E3648A-02

S E R V I C E N O T E

E3648A DC Power Supply

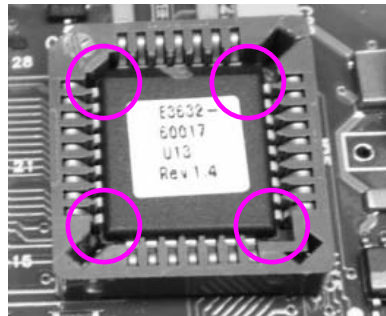
When the unit is power ON, the display went off immediately.

1. Upon turn on the power supply, if the symptoms are as follows:
 - a. Display light up and then become blank with fan running
 - b. Display light up and hang with fan running
2. Turn OFF the power supply.
3. Remove the existing EPROM and replace with a known good EPROM.
4. Refer to the reference designator of EPROM according to model:

5. Turn ON the unit again and see if the symptom disappears.
6. If the symptom still occurs, turn OFF the unit.
7. Return the unit to factory for Failure Analysis.
